Jul 19th, 2024

MVSV-220 、 MVDC-300 electric connection(power saving) design change Notification

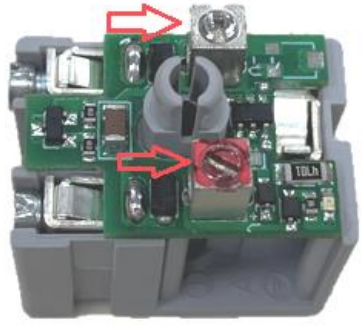
In response to the feedback needs of some markets, change the appearance configuration to facilitate smooth wiring and identification operations.

Before	After
 <p>1 wire terminal. No color identification for terminals. Green LED light.</p>	 <p>2 wire terminals. The red terminal represents the positive terminal. Red LED light.</p>
